| REQ. ITEM | PART NO. | DESCRIPTION | SYMBOL |
|---|----------|-------------|--------|
| THE TECHNICAL MATERIEL CORP. MAMARONECK, NEW YORK | | | |

| | RTP | | | 10-10-55 |

CK-314

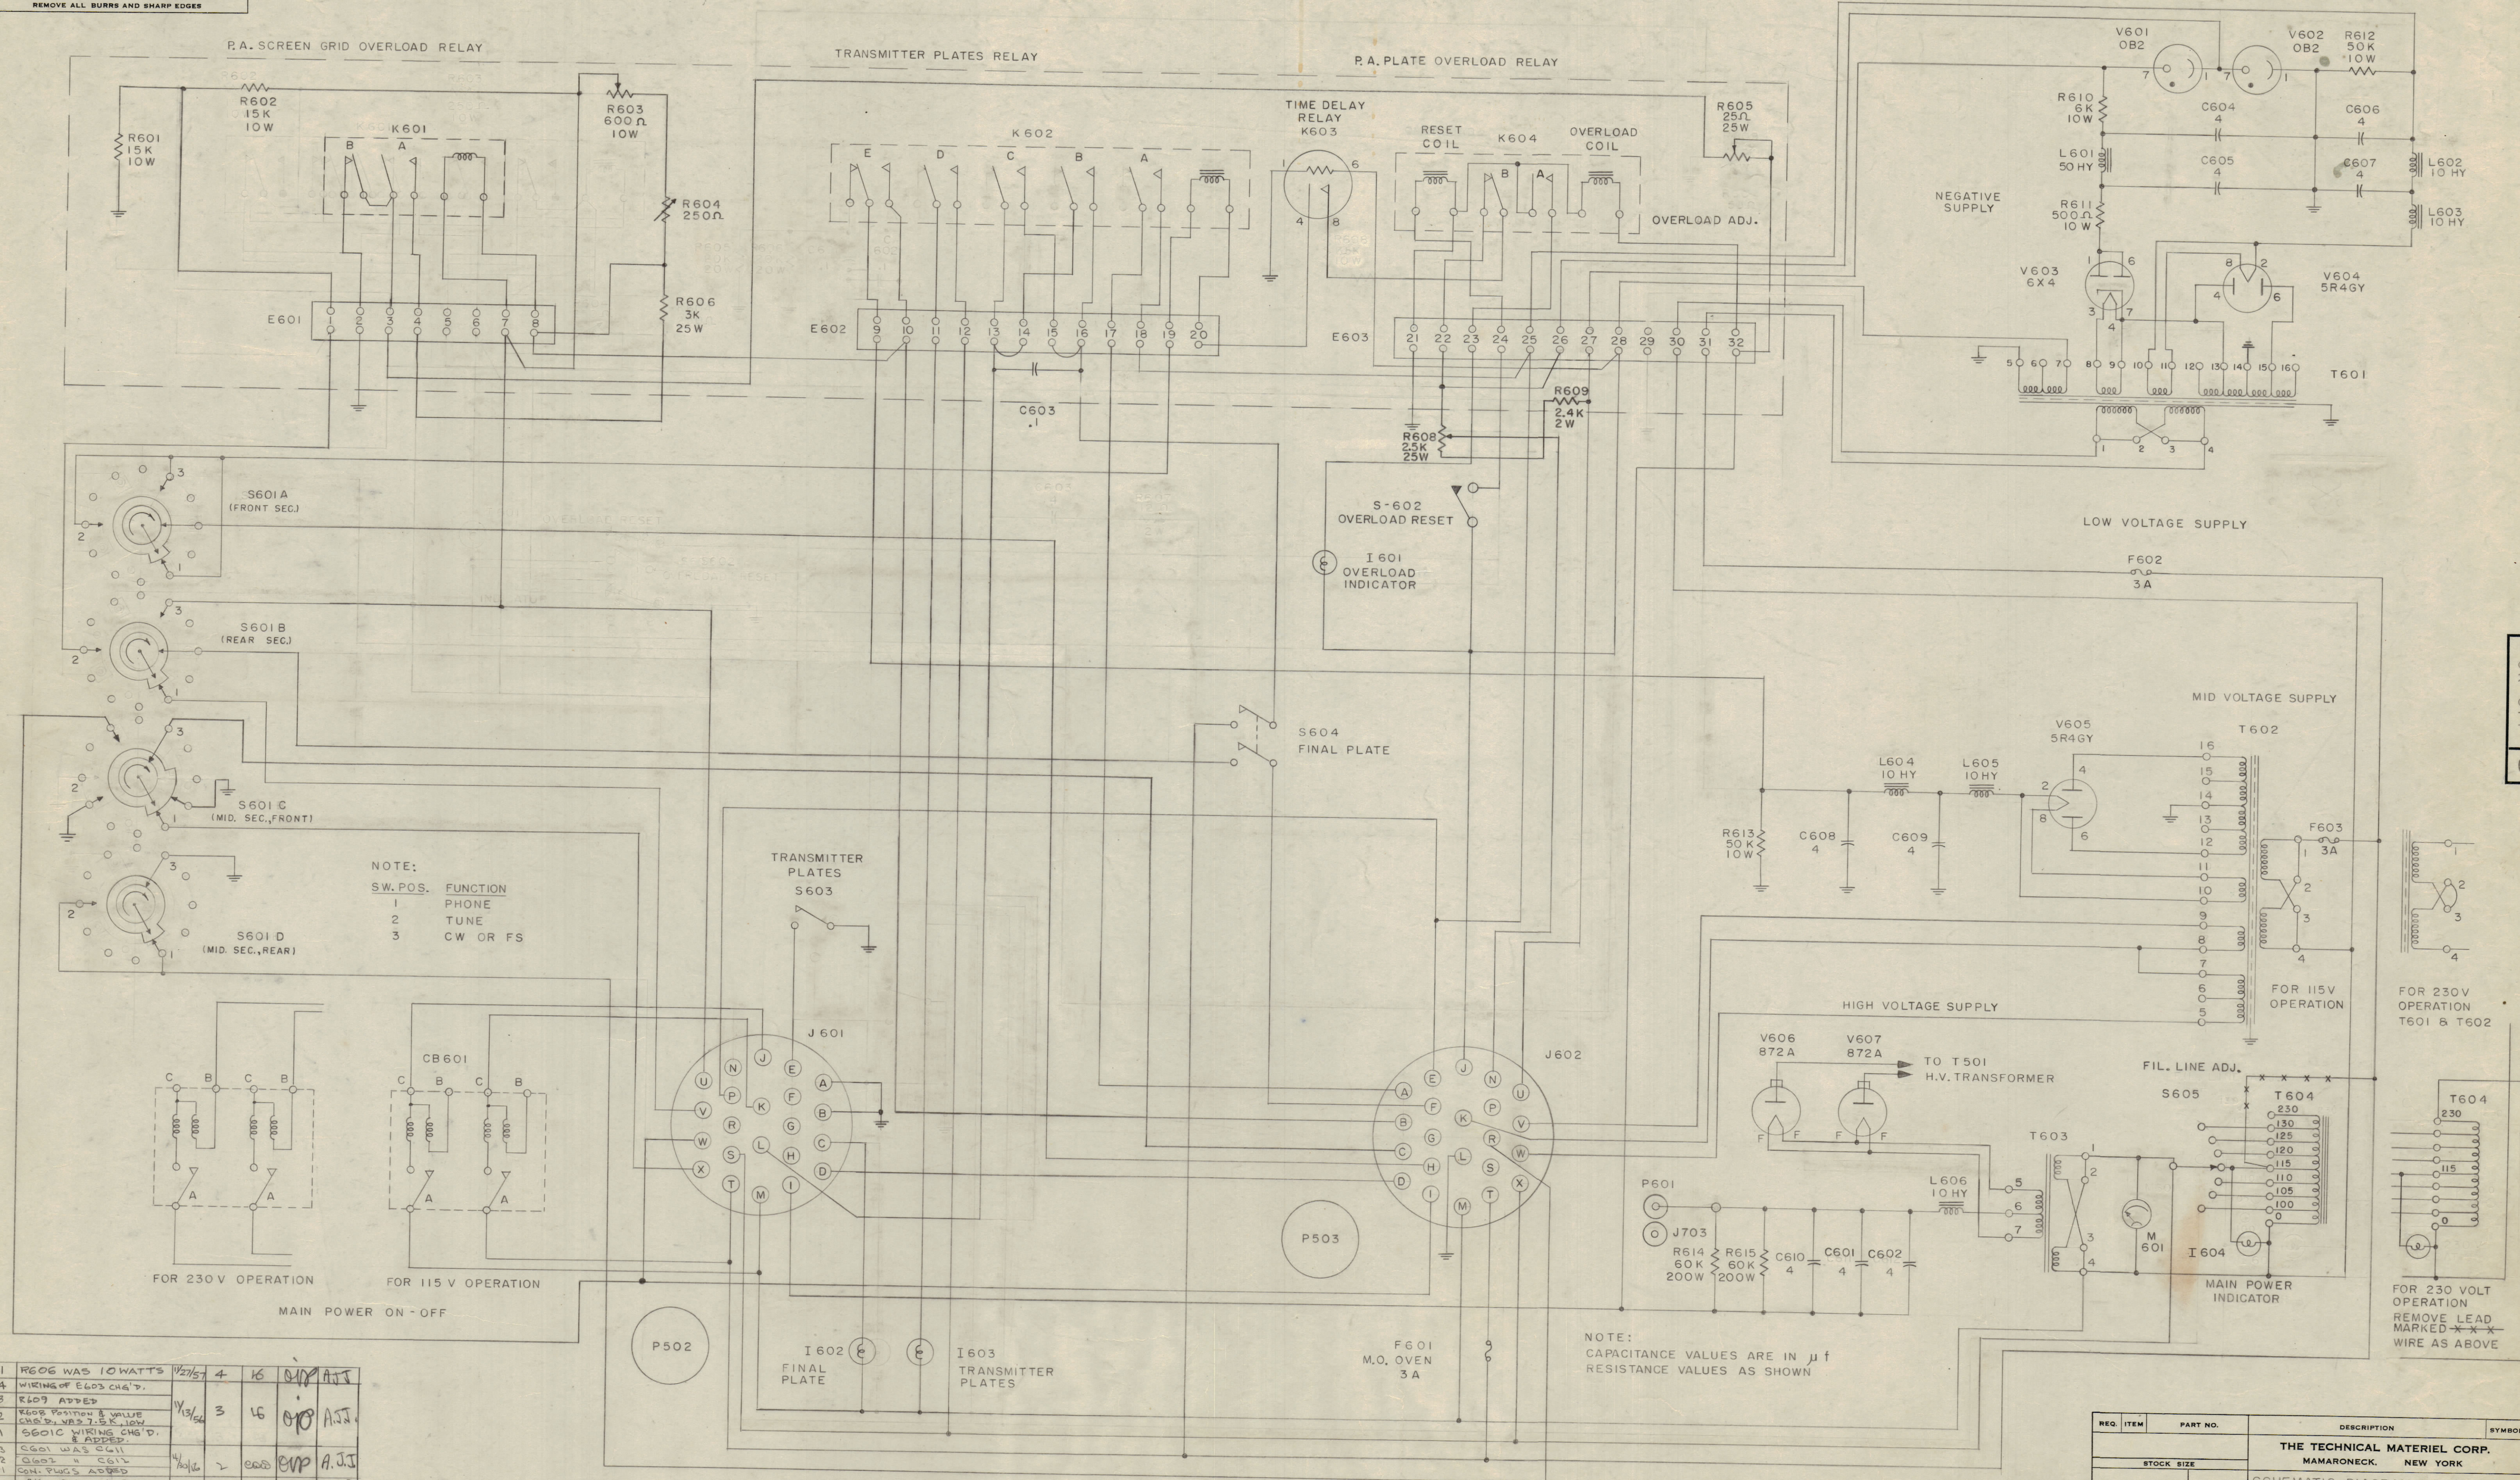
| D | 1 | R606 WAS 10WATTS | 1/27/57 | 4 | 16 | W.P.A.S.S. |
| | 4 | WIRING OF E603 CHG'D. | | | | |
| | 3 | R609 ADDED | | | | |
| C | 2 | R602 POSITION & VALUE CHG'D. WAS 7.5K, 10W | 1/3/56 | 3 | 16 | W.P.A.S.S. |
| | 1 | S601C WIRING CHG'D. & ADDED | | | | |
| B | 3 | S601 WAS COIL | | | | |
| | 2 | C602 " " COIL | 4/10/56 | 2 | 16 | W.P.A.S.S. |
| | 1 | COIL TUNGS ADDED | | | | |
| A | 1 | 3K 10W ON R606 ADDED | 2-2-56 | 1 | 16 | W.P.A.S.S. |
